ALLAMAKEE CSD MIDDLE SCHOOL HVAC UPGRADE
WAUKON, IOWA

ADDENDUM 03
March 11, 2026

Allamakee Community School District Waukon Middle School HVAC Upgrade

ADDENDUM NUMBER 3

E-101B

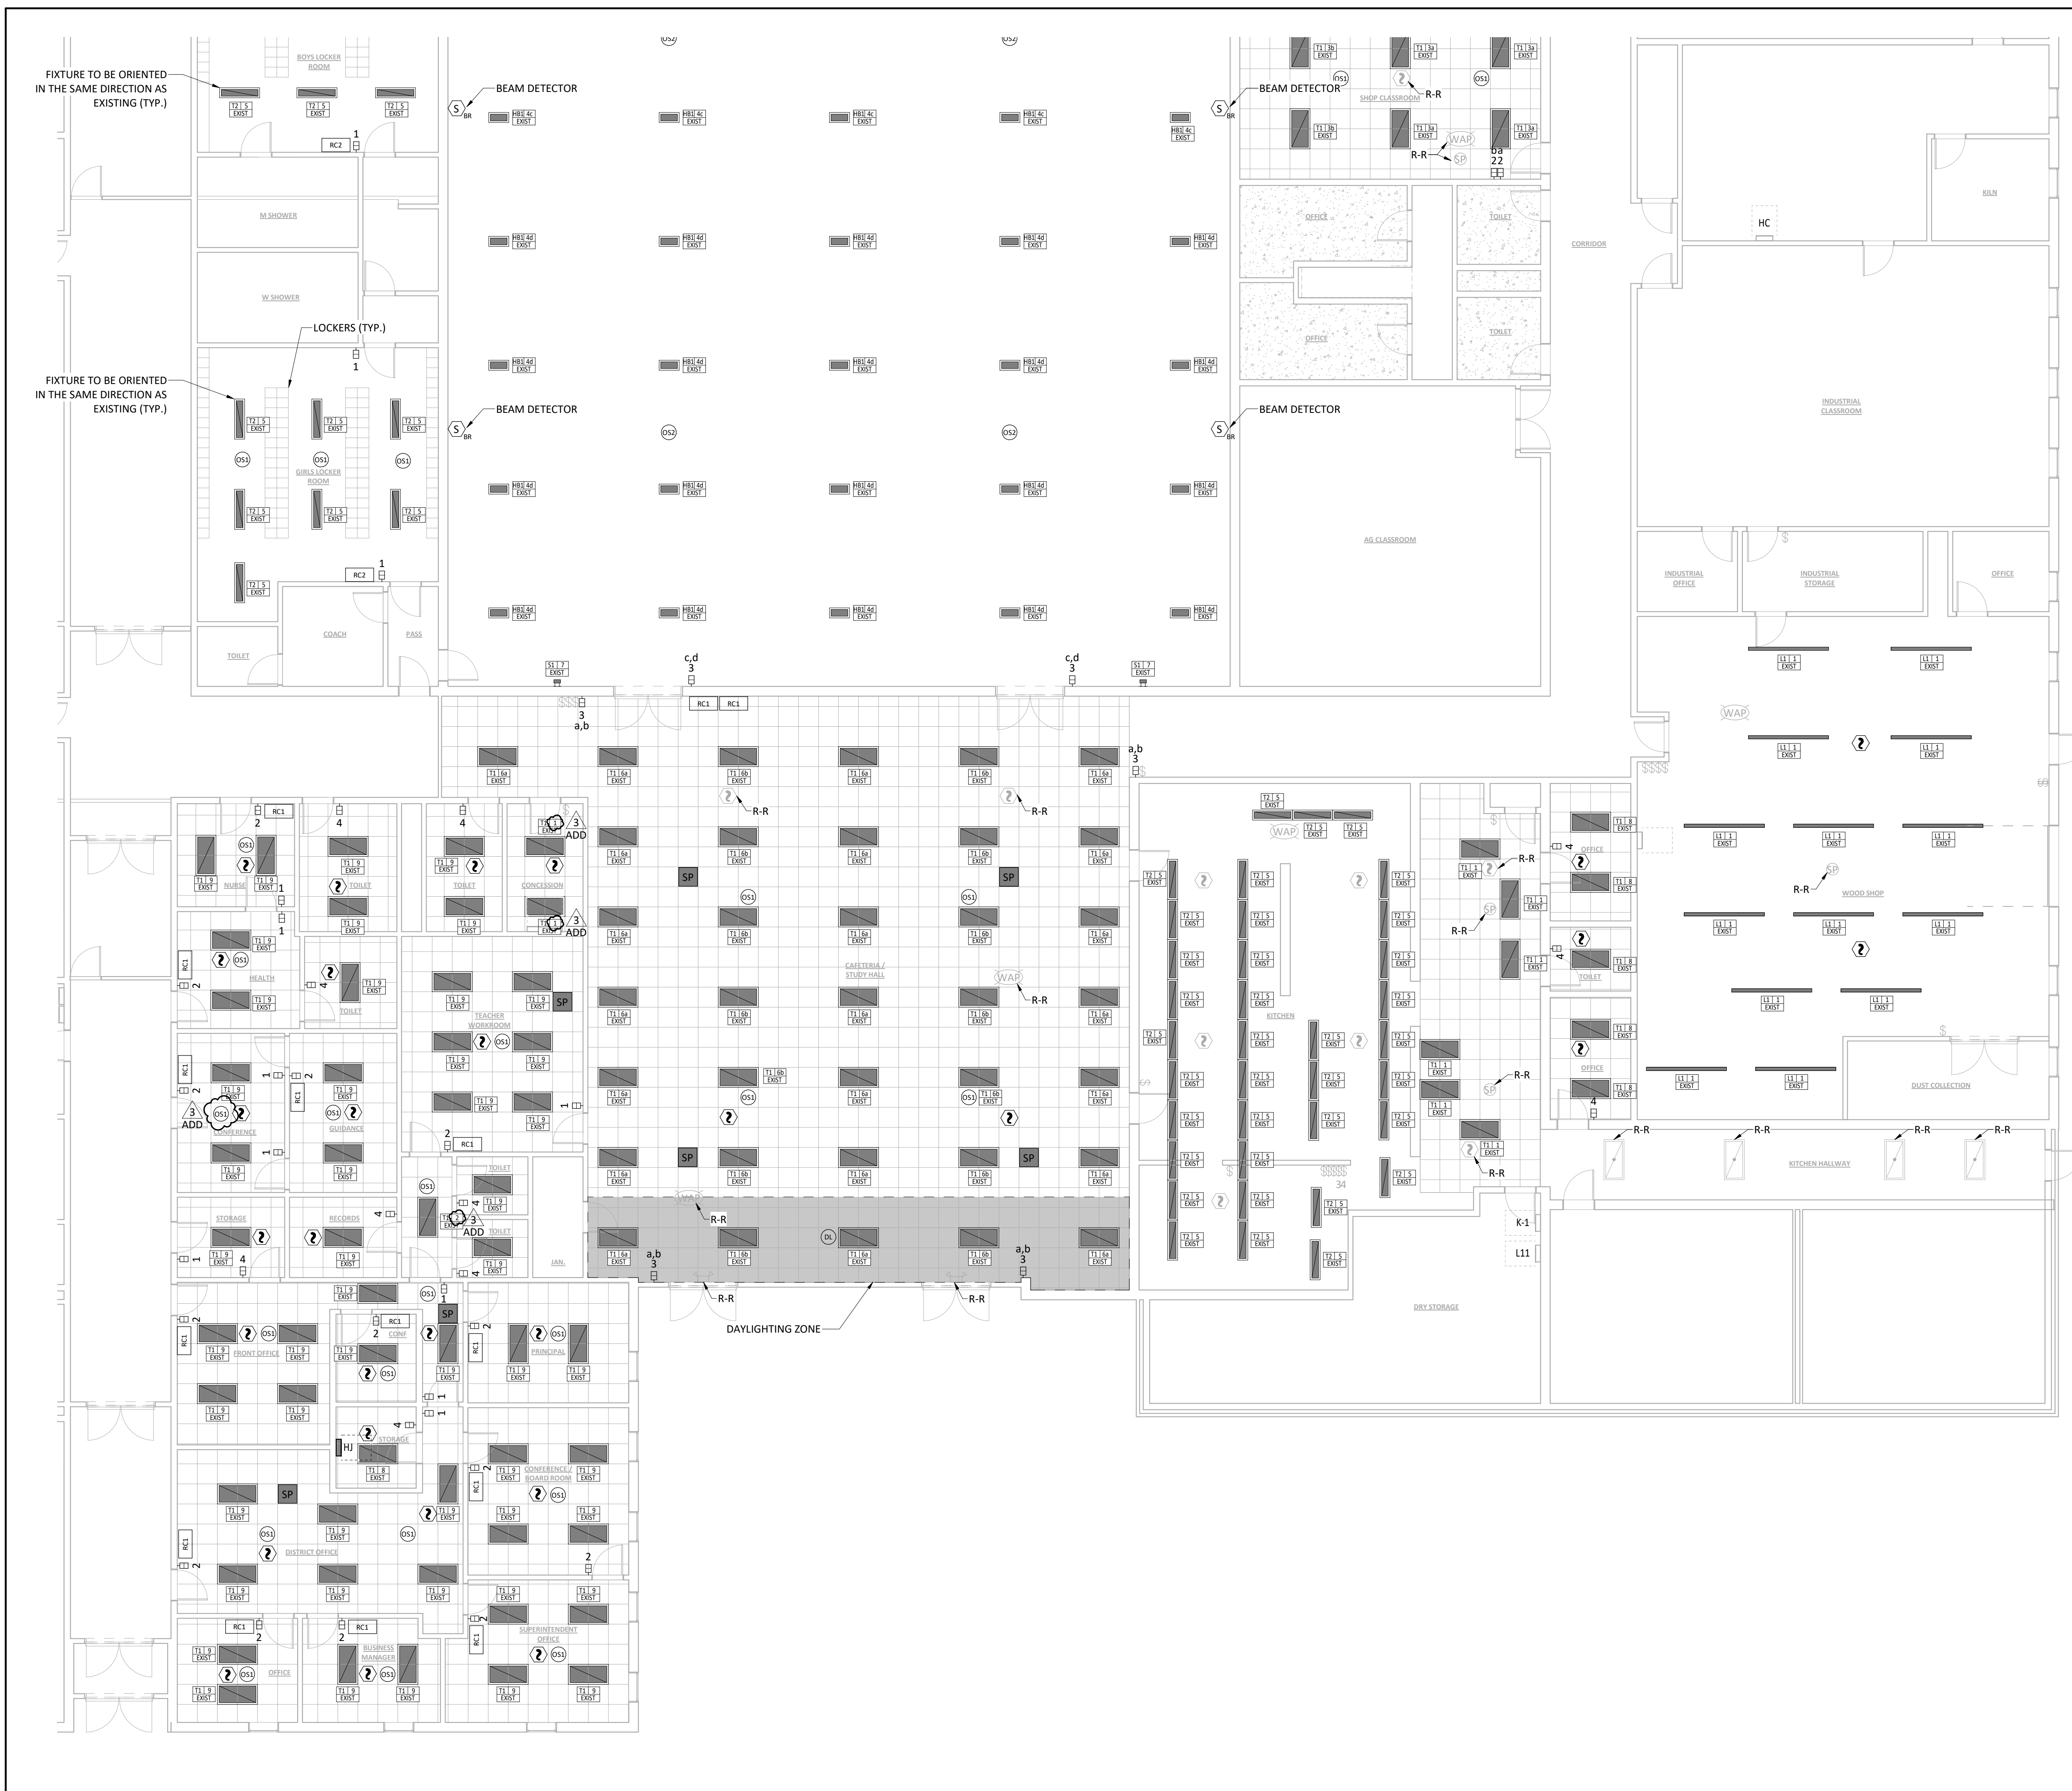
- M3-4 Drawing **M-604 – MECHANICAL SCHEDULES**
1. Added glycol collection schedule.
- E3-1 Drawing **E-101B – ELECTRICAL PLAN – AREA B**
1. Added and tagged direct connection symbol for glycol tank in mechanical room.

2. Added toggle type disconnect switch for glycol tank in mechanical room.
- E3-2 Drawing **E-110A – LIGHTING PLAN – AREA A**
1. Revised light fixtures in concessions room to sequence of operation #1.

E-605

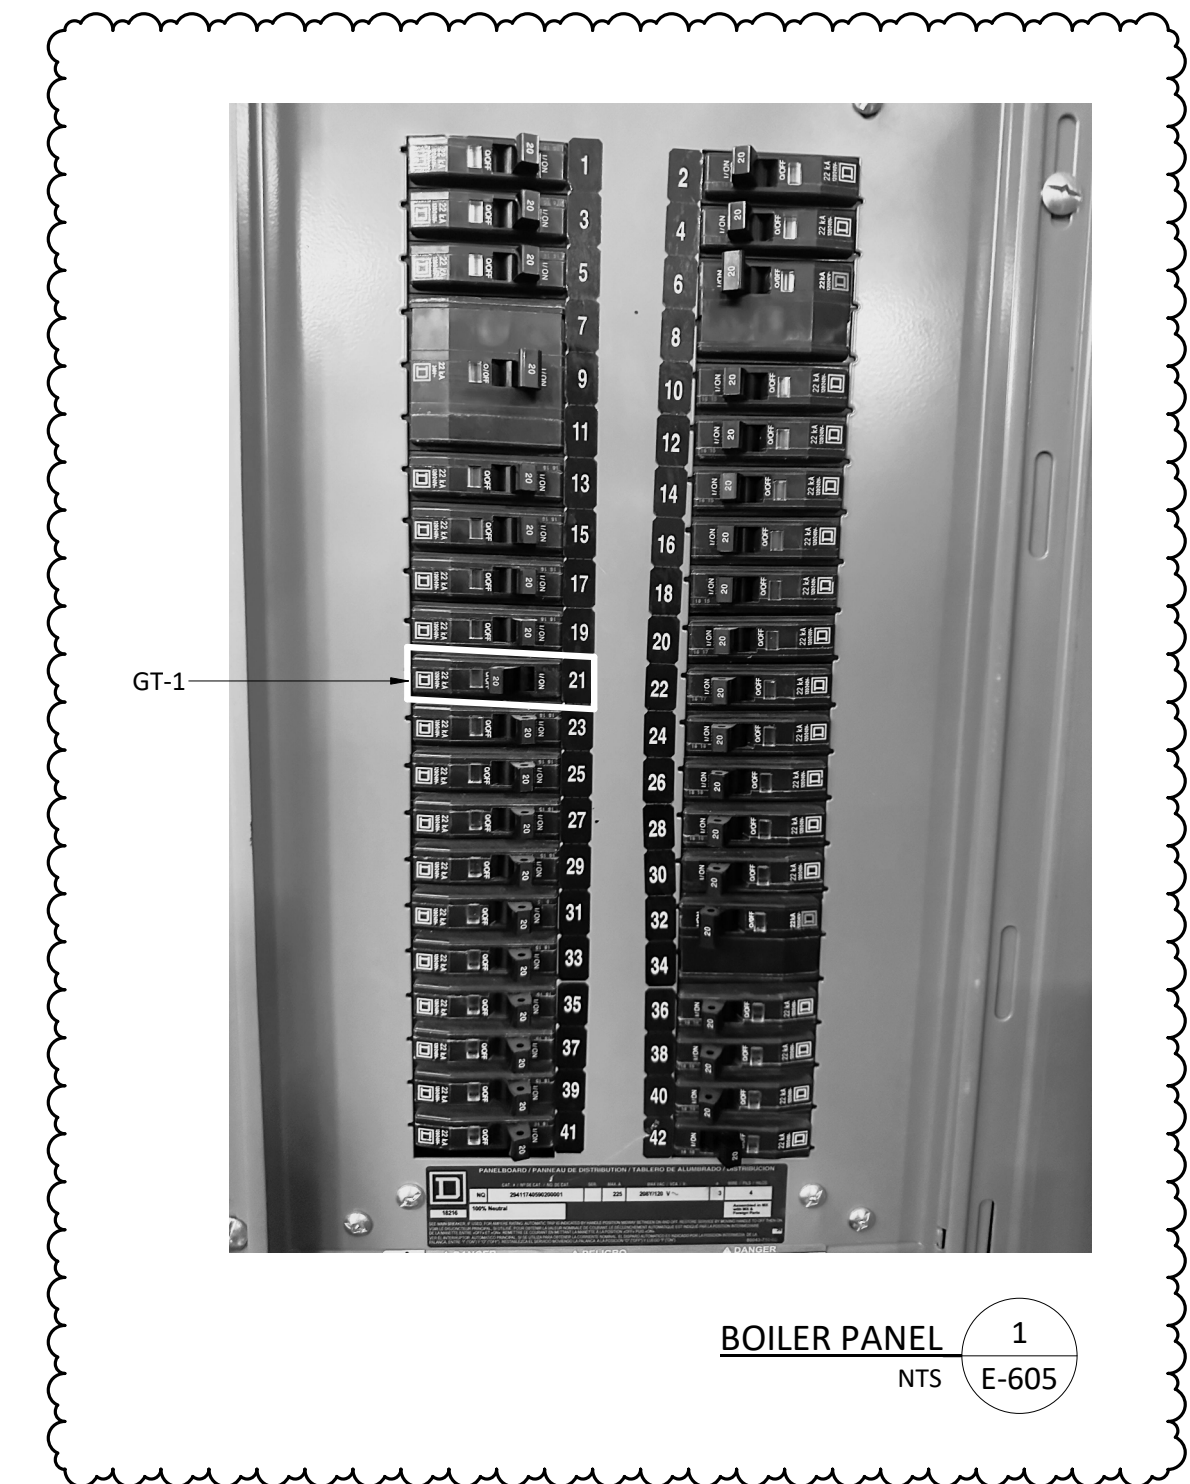
3. Revised panel DB’s mains type to MCB.
- E3-5 Drawing **E-605 – ELECTRICAL PANEL SCHEDULES - PHOTOS**
1. Added photo of boiler panel in mechanical room to show where GT-1 shall be circuited.

BOILER PANEL 1
NTS E-605
